Before the
FEDERAL COMMUNICATIONS COMMISSION
Washington, D.C. 20554

PR Docket No. 92-235

PETITION FOR RECONSIDERATION

BY SEA INC.

Figure 1
6.25 kHz channel bandwidths spaced 6.25 kHz

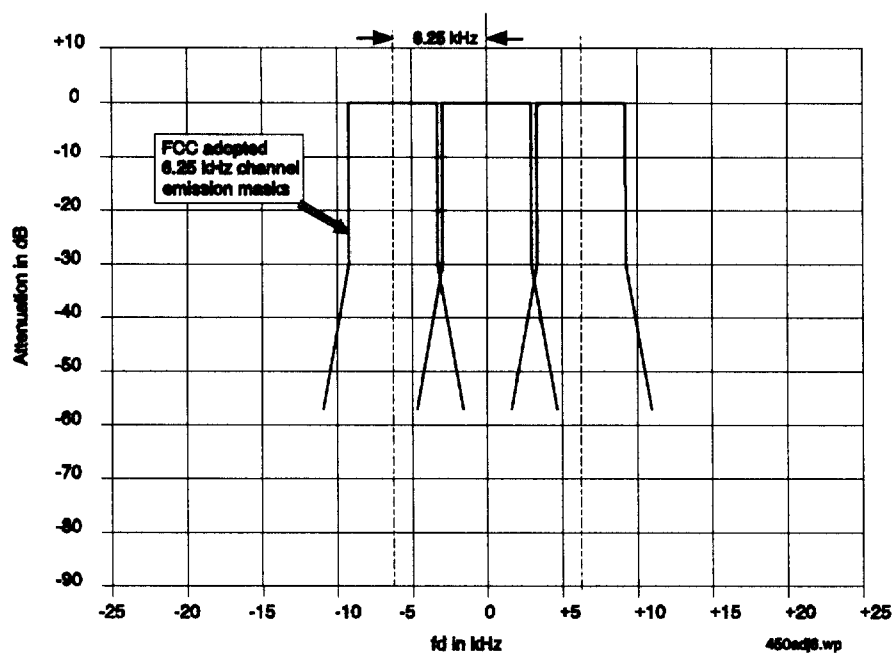
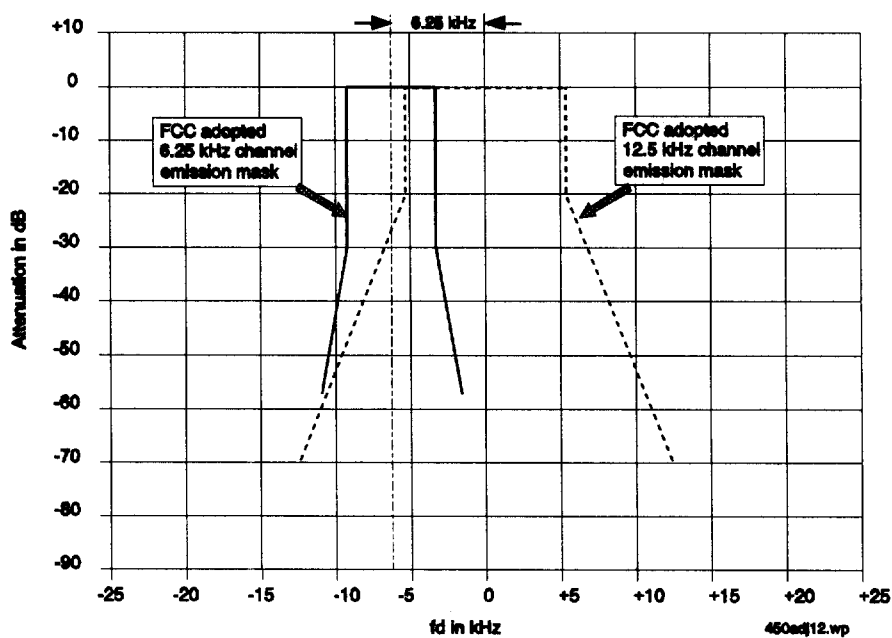
The 6 kHz authorized bandwidth leaves a mere 250 Hz guard band between nominal (zero frequency error) edges of the authorized bandwidths of two adjacent 6.25 kHz-spaced narrowband channels, as is the case in the 421-512 MHz band. Further, the emission mask adopted by the Commission for 6.25 kHz and 12.5 kHz channels will actually *overlap* when placed 6.25 kHz apart, illustrating the problem at 421-512 MHz created by the new rules, as shown graphically in Figures 1 and 2 below. It should be noted that receiver modulation acceptance bandwidths must be wider than the authorized bandwidths represented by the emission masks shown below in Figures 1 and 2.

It is immediately apparent from the foregoing illustrations that geographic separation will always be required between adjacent narrowband systems that operate in the 421-512 MHz frequency band. Tight frequency stability limits would, therefore, achieve nothing with regard to adjacent channel protection, since adjacent channels cannot coexist in the same area.

As discussed above, the band plan and emission masks adopted in the Report will require geographic separation between adjacent 6.25 kHz-spaced channels in the 450 MHz band. This is because 6 kHz authorized bandwidth is simply too large for 6.25 kHz-spaced channels.

The Commission should be aware that, at the very least, the necessity of geographic separation will make any spectrum efficiency benefits in converting to 6.25 kHz channels difficult to quantify. At worst, there may be no benefits^{4/}. SEA requests the Commission to reduce the authorized bandwidth for 6.25 kHz channel bandwidth emissions from the adopted 6 kHz, back to the originally-proposed 5 kHz authorized bandwidth. This would make same-area adjacent 6.25 kHz channel operation possible

in the 421-512 MHz band.^{5/} The same narrowband emission mask (5 kHz authorized bandwidth) should be used for the 150-174 MHz band so that there will be a common mask for both bands, thereby enabling equipment compatibility for multimode radios.

Figure 3

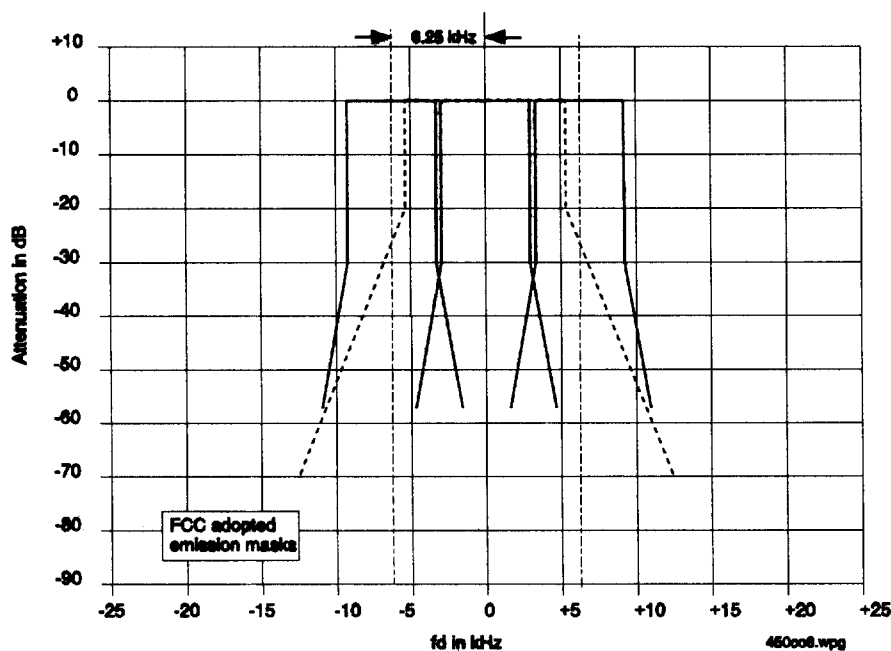
The efficiency standard adopted is less than meaningful because, with 6.25 kHz/12.5 kHz channel spacing such as that in the 450 band, the emission masks are such that a "12.5 kHz channel" uses almost as much spectrum as three 6.25 kHz channels^{7/}. Given the adopted masks, a 12.5 channel width channel, in SEA's view, cannot be considered equivalent in efficiency to two 6.25 kHz channels. This is graphically evident from the figure below.

^{7/} That is, a 12.5 kHz channel must be considered "co-channel" to the associated on-channel 6.25 kHz channel and both adjacent 6.25 kHz channels.
